Summary of Proposed Amendments
Phase 2
Weldale Street, Reading

Non-Material Amendment Application

January 2022

This document summarises the changes made to the drawings associated with planning permission 170326 for the former Wickes Site, Reading

Proposed Lower Ground Floor Plan, 1:500 (3622-SC-0199EE)

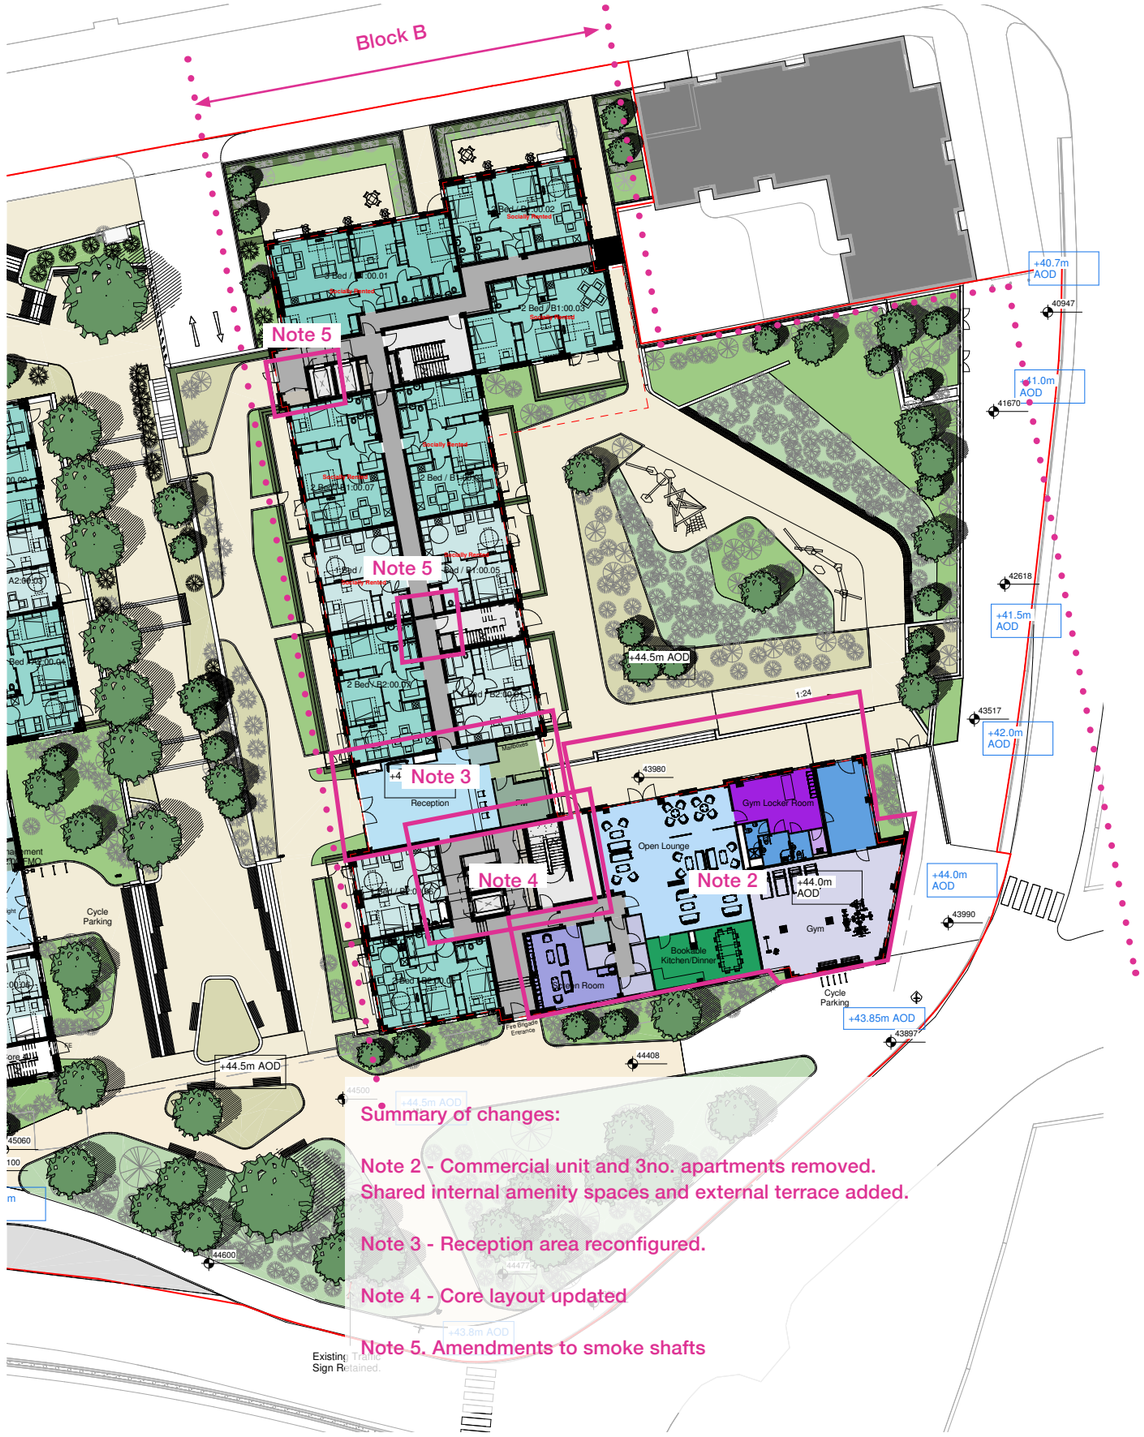
- Note 1 - As part of design development the commercial bin store and commercial plant areas have been removed.
- Due to new sprinkler recomendations for residentail building a new dedicated sprinkler tank has been added.
- CHP plant has been repaced with localised air source heat pumps requiring plant areas to be reconfigured.
- B1 Landscaping amended to suit updated levels.
- Carpark updated to suite layout changes, however carpark numbers to remain the same. Where space permits additional accessible spaces have been provieded.
- EV charging has been increased to provied on charger for every two spaces. these have been evenly distributed so all spaces can benifit from having access to a charger
- Note 1a - To ensure proper sprinkler cover to the below podium carpark a further additional sprinkler tank has been located below the predestrian ramp.

Proposed Ninth Floor Plan, 1:500 (3622-SC-0209R)

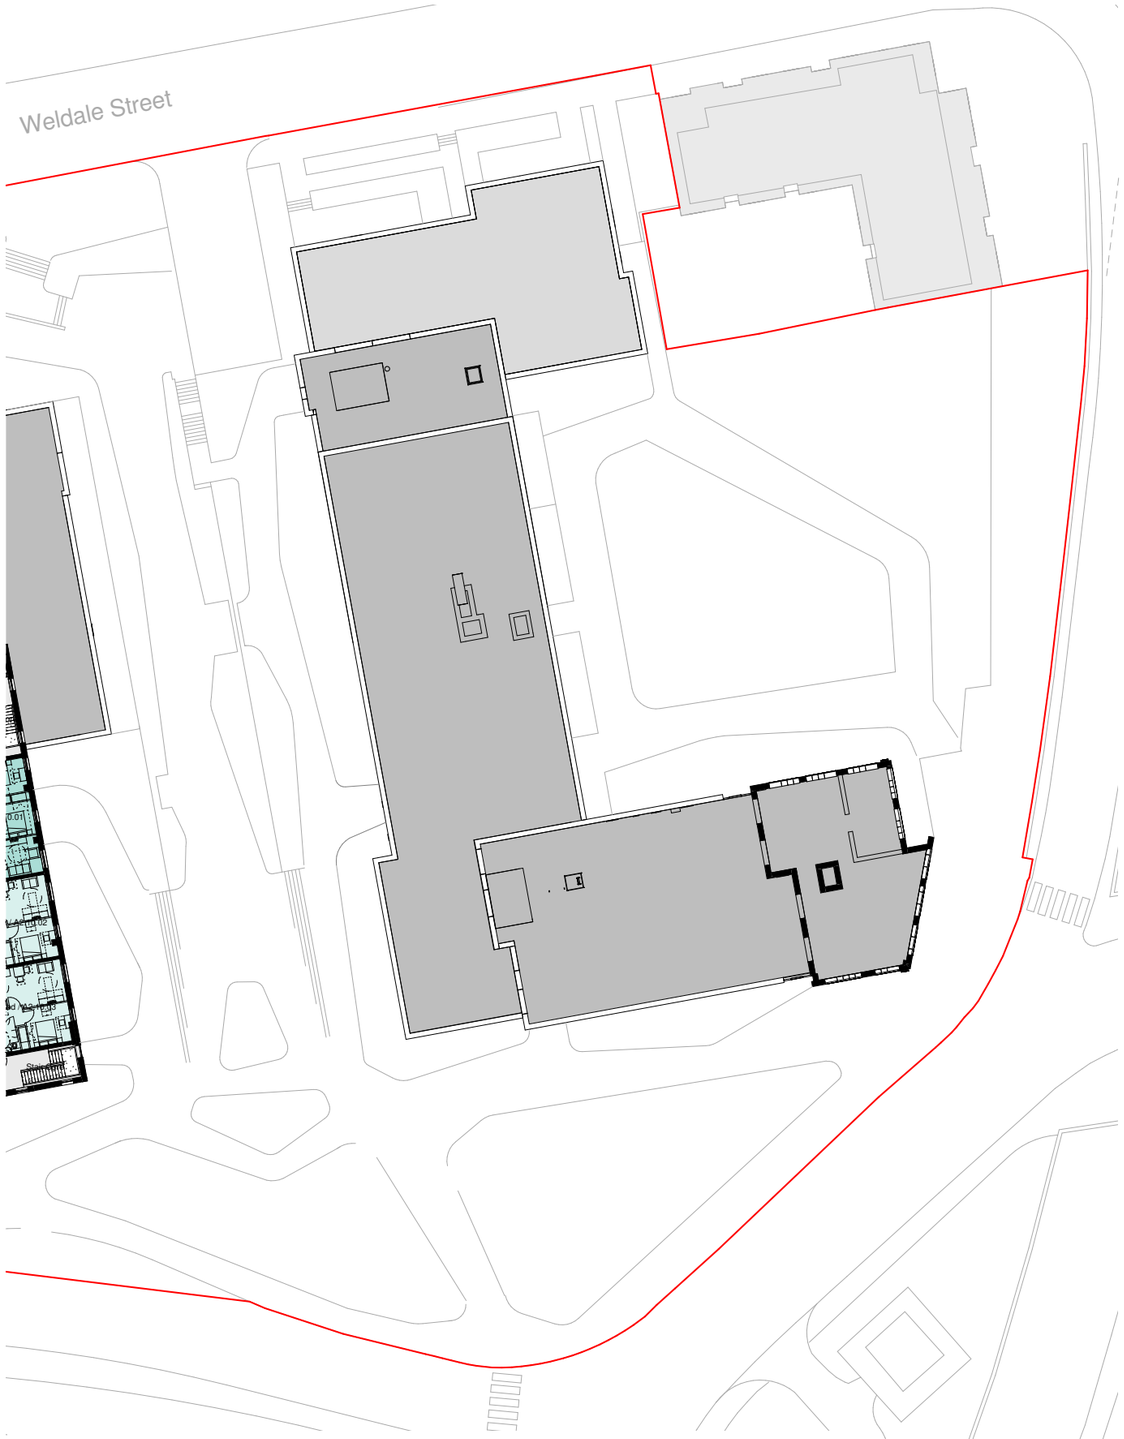
Note 4c - Core layout updated. 1 no. apartment layouts updated to suit.

Note 5 - Amendments to smoke shafts

Note 7 - Note 7 - Blue/Green roof to all roof areas. Blue/Green roof shown indicatively, detailed Drainage Strategy for Blocks B1 & B2 to be submitted to discharge the remainder of Condition 34 + Introduction of PV panels located as indicated

Extract from proposed Site Elevation South, 1:200 (3622SC-0300G),

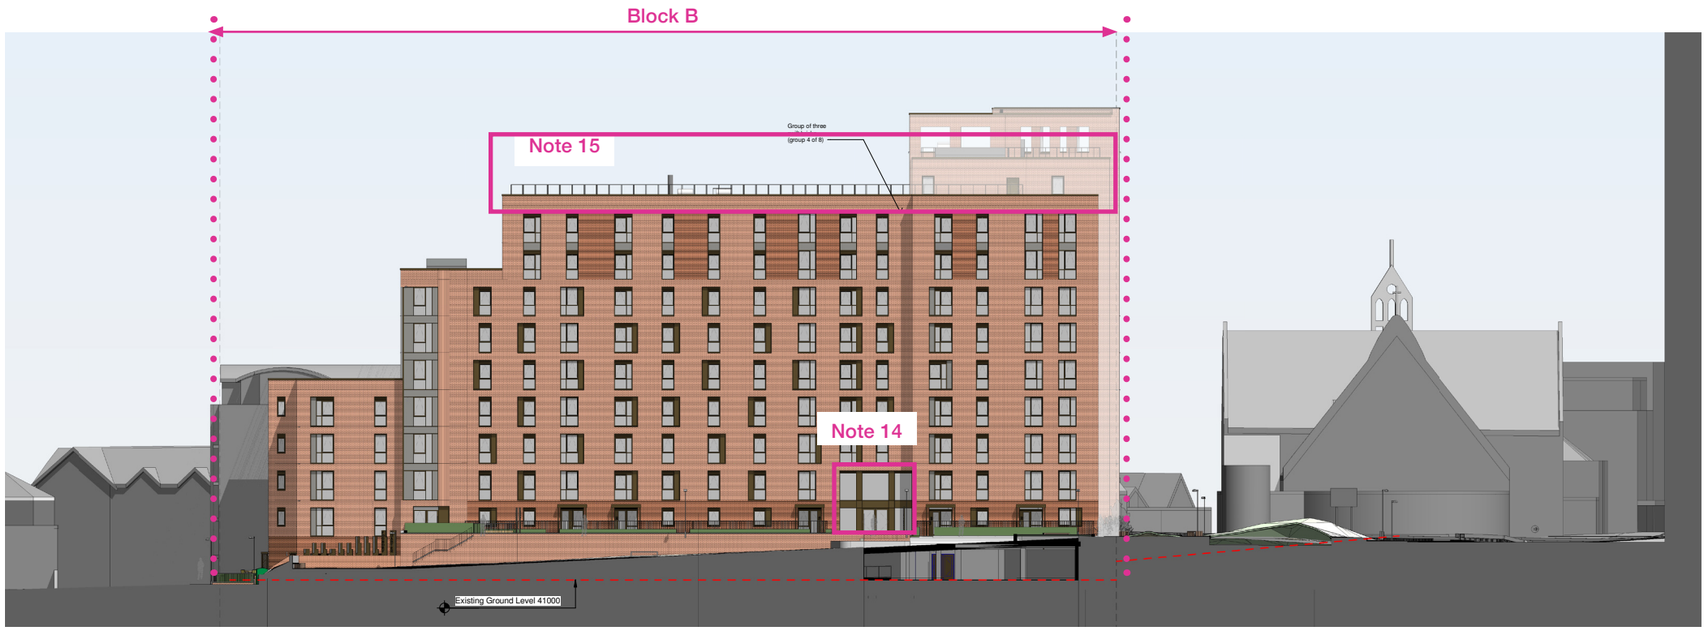
Arrangement of corner glazing updated to align with fire brigade access requirments

PVs + Edge Protection to roof areas

Fenetration updated to rationalize windows and allow for reception back of house area

PVs + Edge Protection to roof areas

windows rationalised to suit fire escape half landdings

Fenetration updated to suit updated reception area

Proposed Extract of B1/B2 West Elevation, (Drawing 3622-SC-0405F)

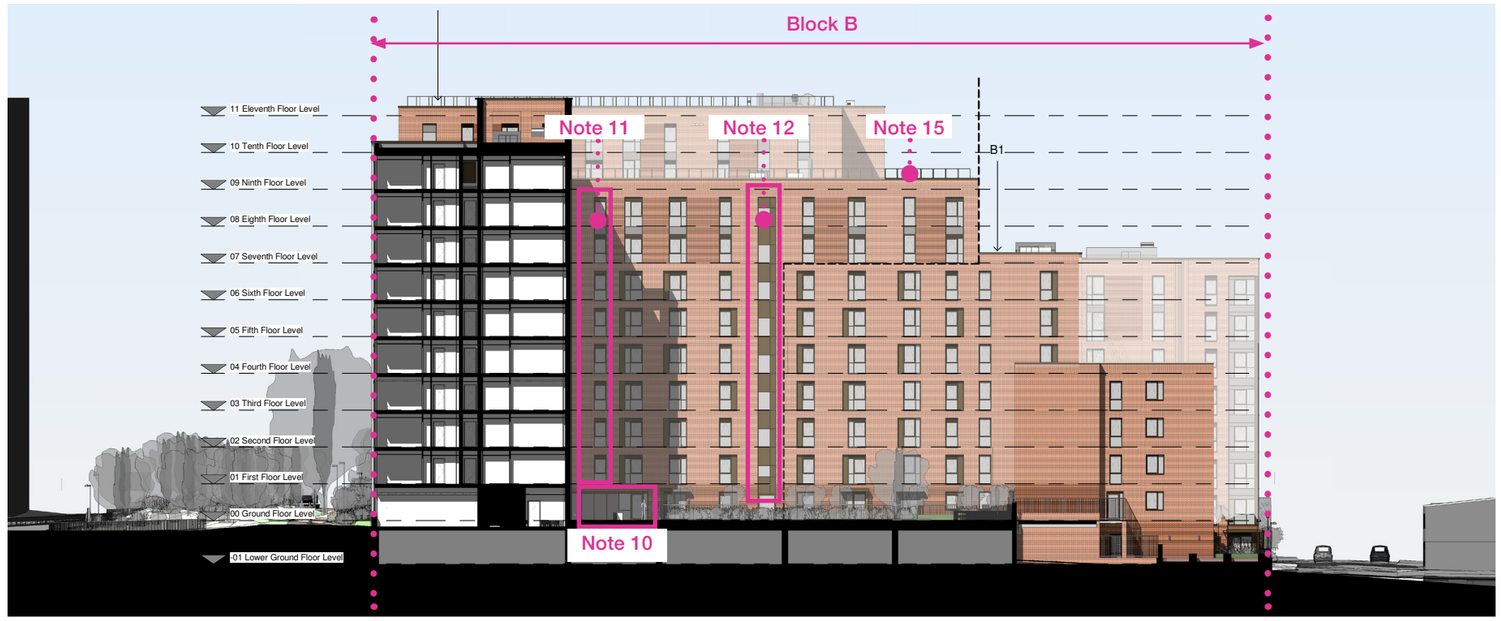
Note 14- Fenestration updated for double height reception space.

Note 15- PVs + Edge Protection to roof areas

B1 South Elevation, 1:500 (Drawing 3622-B1-0301D)

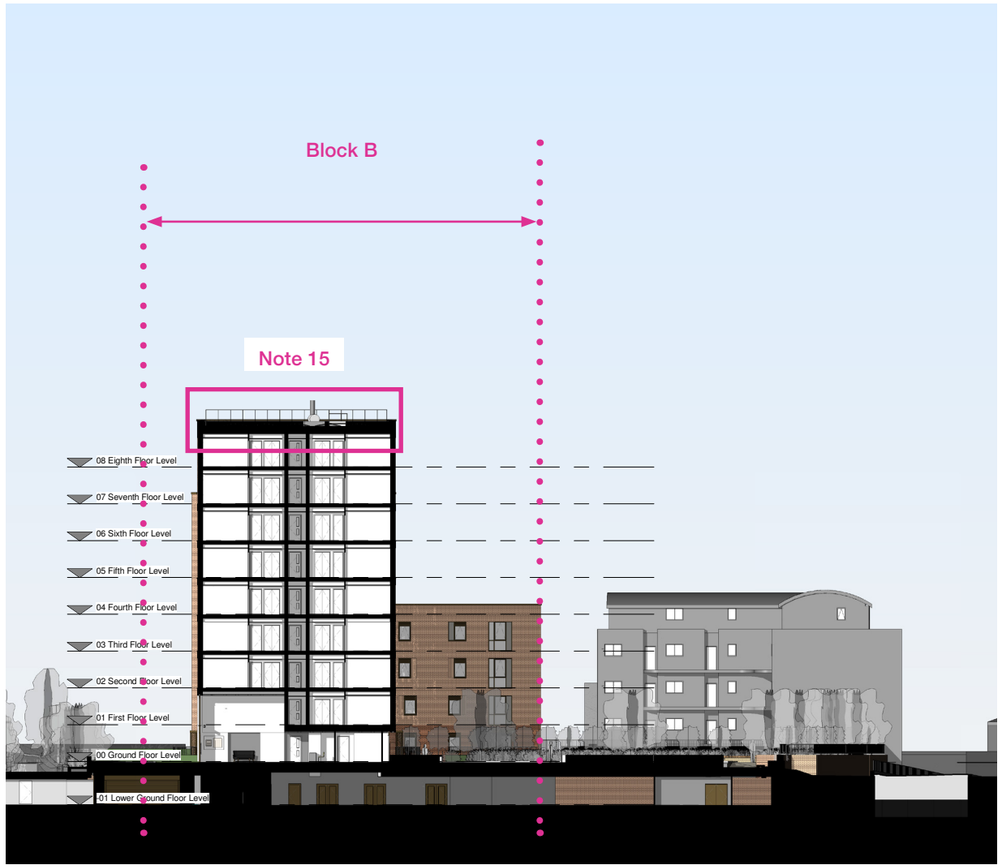
Note 15- PVs + Edge Protection to roof areas

Proposed Site Elevation - South, 1:500 (Drawing 3622-SC-0300G)

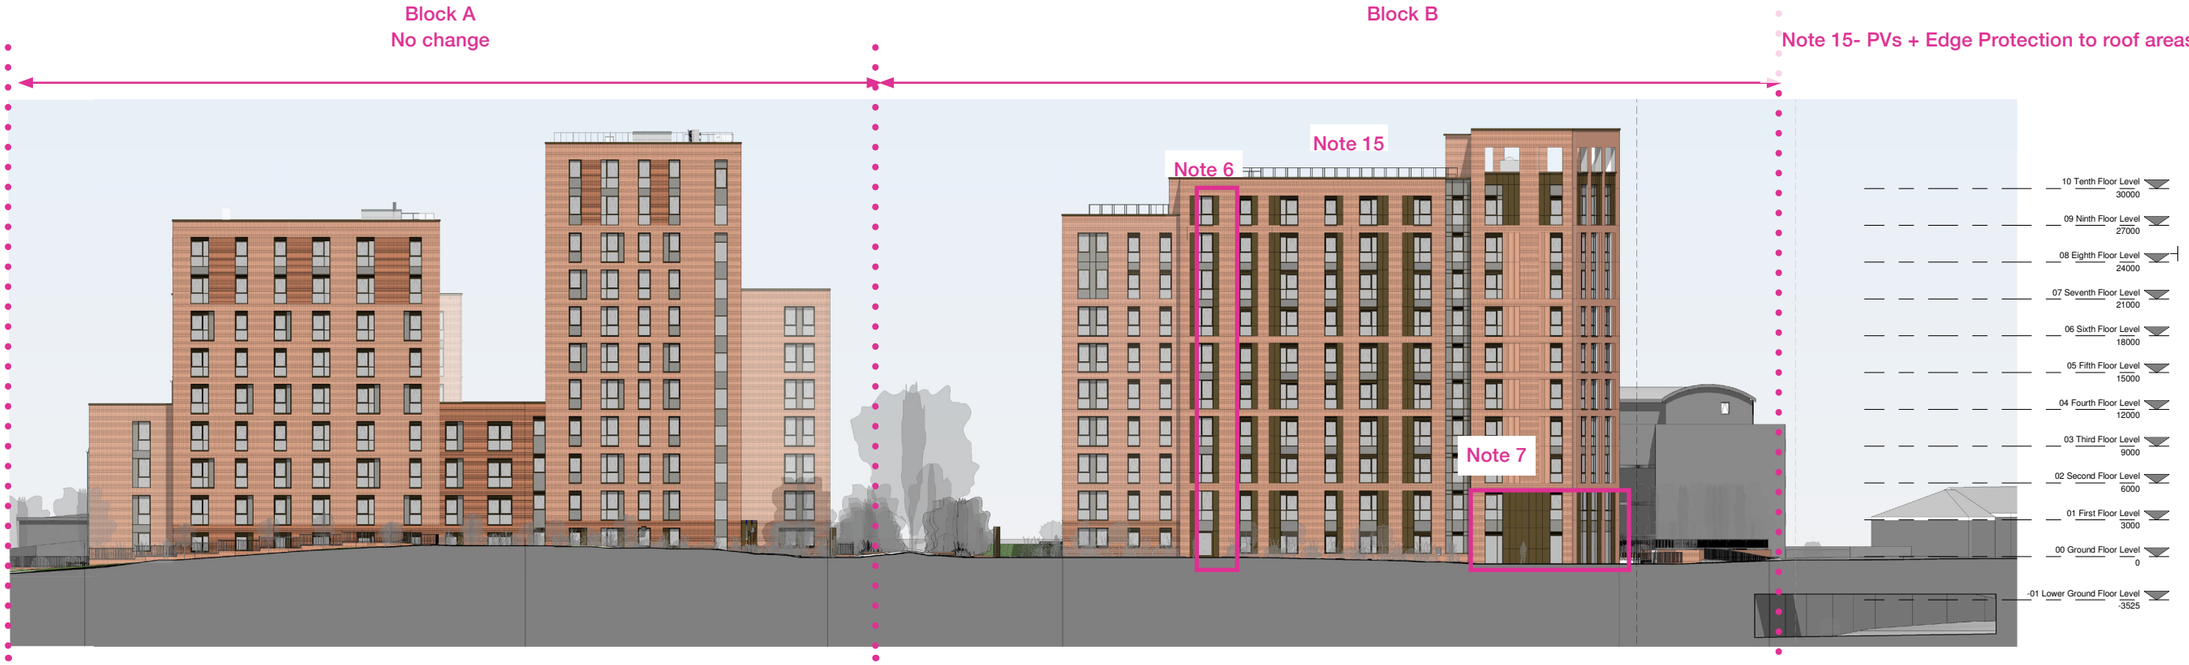
Note 6- Curtain wall containing Firemans entrance updated to ensure mullion position consistancy up the buildings facade.

Note 7 -- Fenetration updated to suit updated ground floor level. .

Note 15- PVs + Edge Protection to roof areas

Proposed Site Elevation - North, 1:500 (Drawing 3622-SC-0302K)

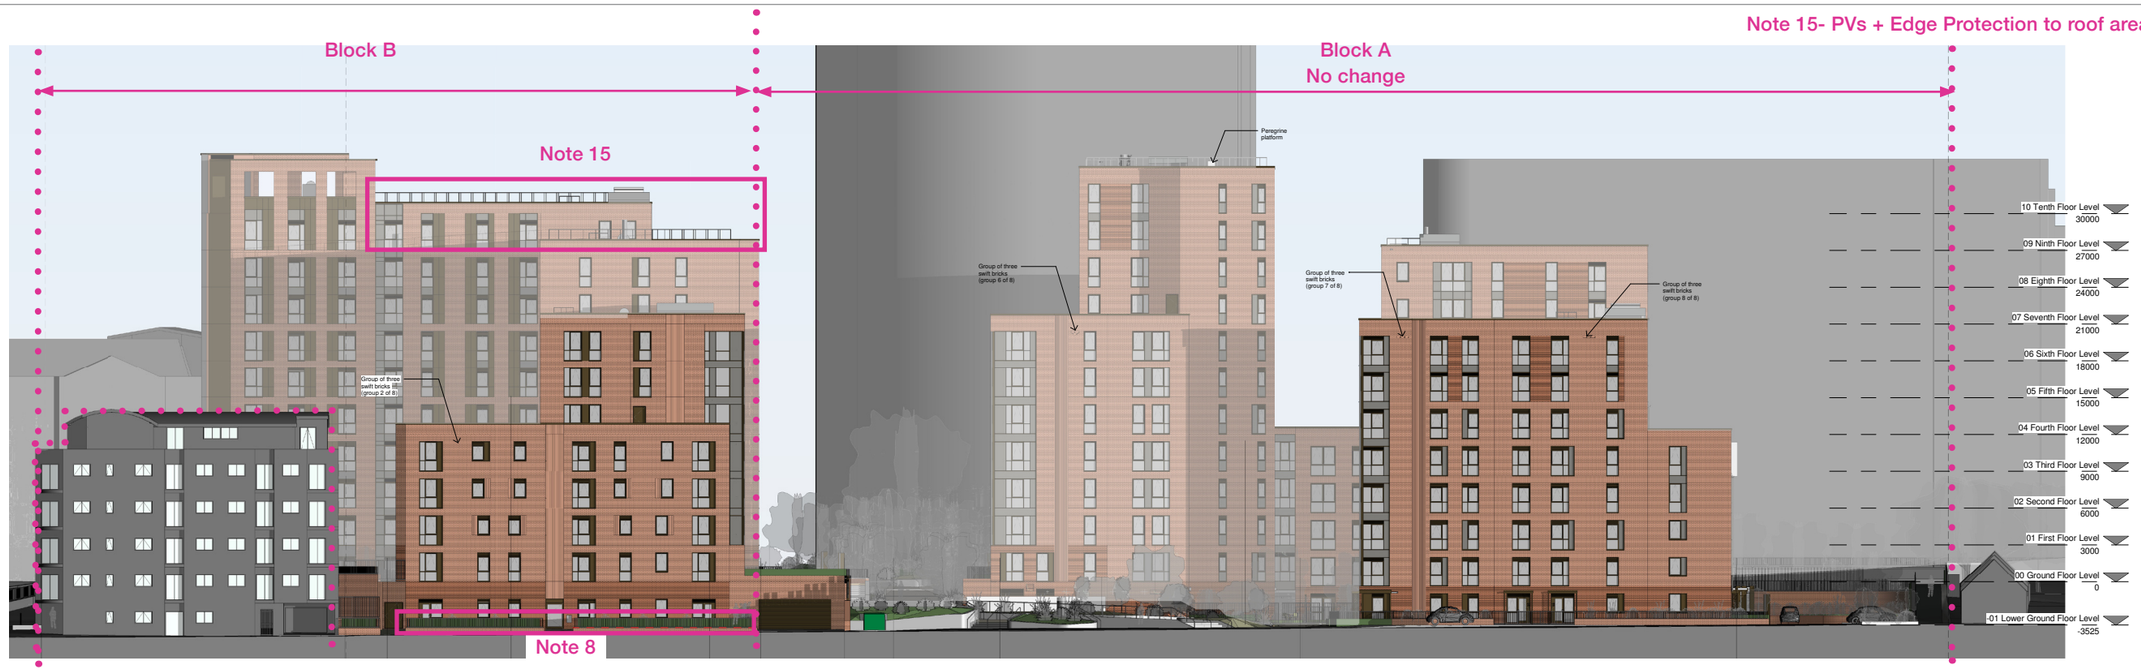
Note 8 - Boundary walls and hard landscaping to B1 North Elevation updated to suit levels.

Note 15- PVs + Edge Protection to roof areas

Proposed Site Elevation - East, 1:500 (Drawing 3622-SC-0303F

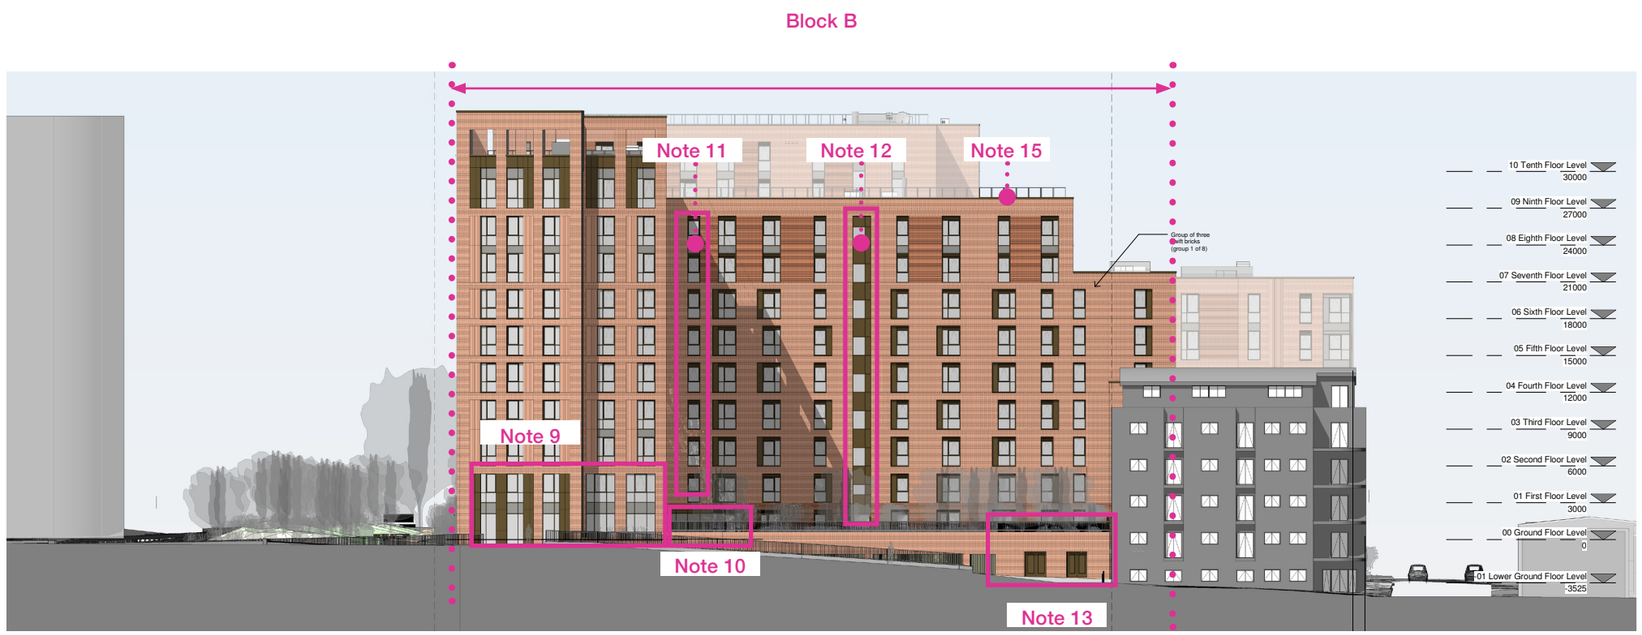
Note 9 - Fenetration updated to suit updated levels and new amenity areas

Note 10 - Fenetration updated to suit updated reception area

Note 11 - Fenetration updated to rationalize windows and allow for reception back of house area

Note 12 - Fenetration updated to suit reconfigured escape stair

Note 13- Substation doors updated In line with UKPS requirments

Note 15- PVs + Edge Protection to roof areas
